**To:** Kristopher Byrd, Well Construction and Compliance Section Manager  
**From:** Travis Kelly, Well Construction Program Coordinator  
**Subject:** Review of Water Right Application G-19030  
**Date:** December 7, 2020

Application # G- 19030

**SUBJECT: Scenic Waterway Interference & General/Local Surface Water Evaluation for Deschutes Ground Water Study Area**

TO: Water Rights Section Date 11/12/2020  
 FROM: Groundwater Section Aurora C Bouchier  
 Reviewer's Name  
 SUBJECT: Application G- 19030 Supersedes review of na  
 Date of Review(s)

D1. Well #: 1 Logid: KLAM 55044

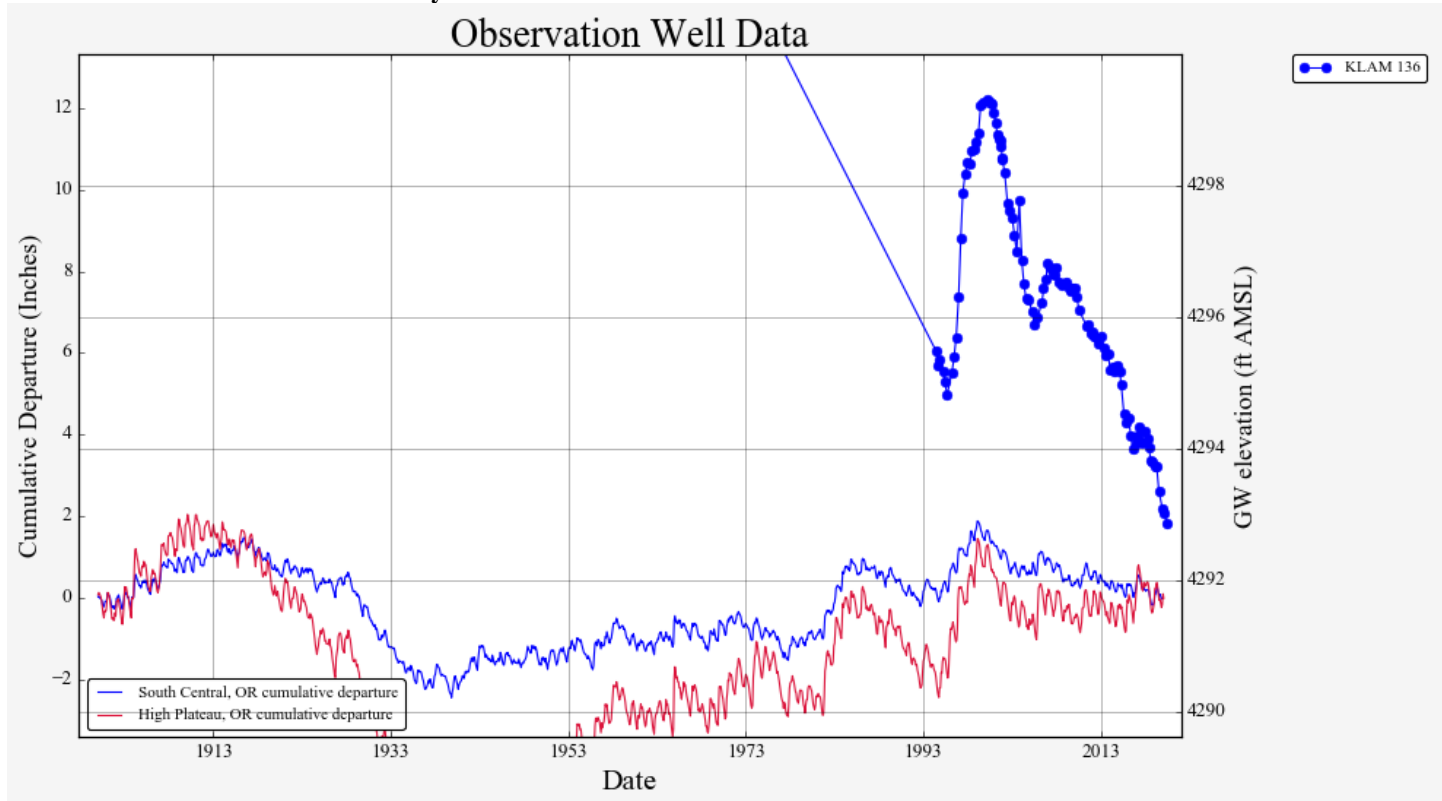
D2. THE WELL does not appear to meet current well construction standards based upon:

- a.  review of the well log;
- b.  field inspection by \_\_\_\_\_;
- c.  report of CWRE \_\_\_\_\_;
- d.  other: (specify) \_\_\_\_\_

D3. THE WELL construction deficiency or other comment is described as follows: \_\_\_\_\_  
\_\_\_\_\_  
\_\_\_\_\_

D4.  Route to the Well Construction and Compliance Section for a review of existing well construction.
